Development Permit # PLDEV-2026-0070

Verified April 14, 2026 (Page 1 of 1)

**S3 | Face Replacement • Dimensions**

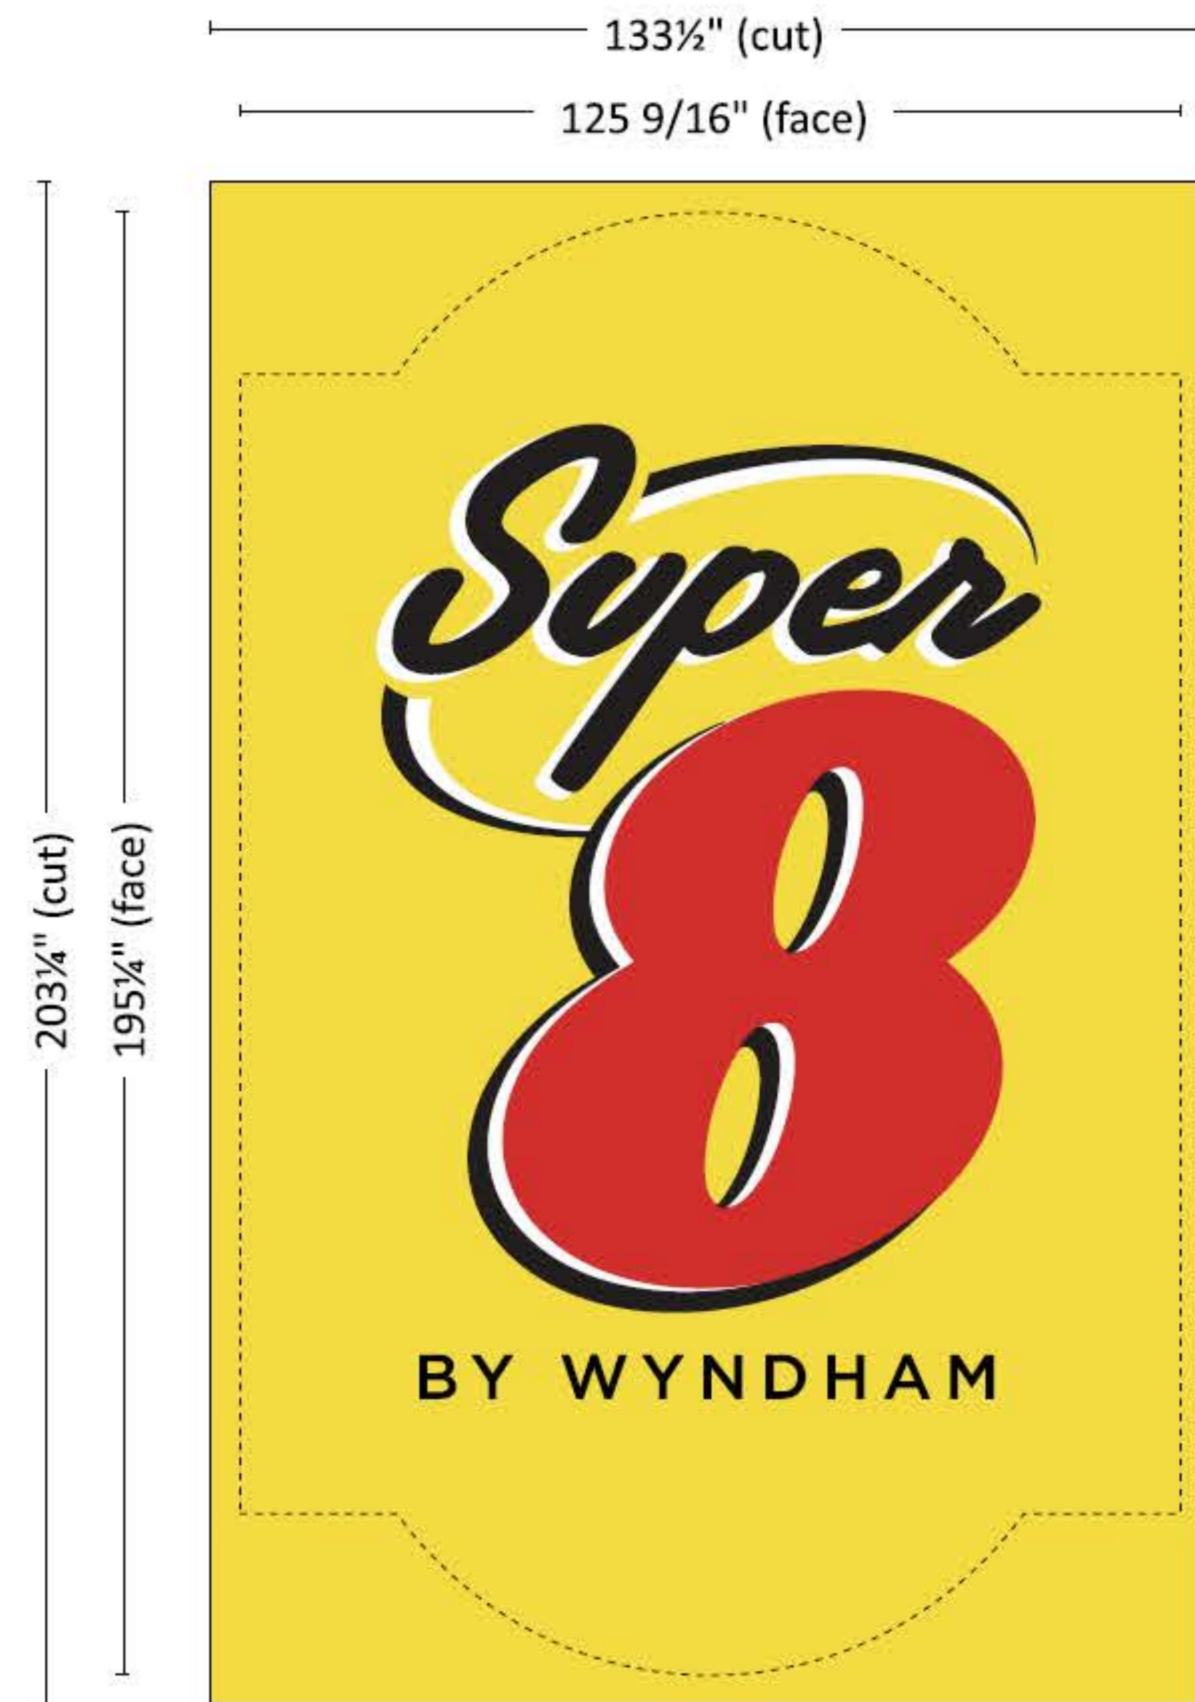
Planner's Note: The Fascia Sign will be illuminated. The Business Frontage of the ground floor of the side of the building to which the sign will be affixed to is 2.44m by 18.288m. The total percentage of the ground floor frontage compared to the sign is 39%. Therefore, the sign must comply with Section 7.9.7 regulations for Fascia Signs.
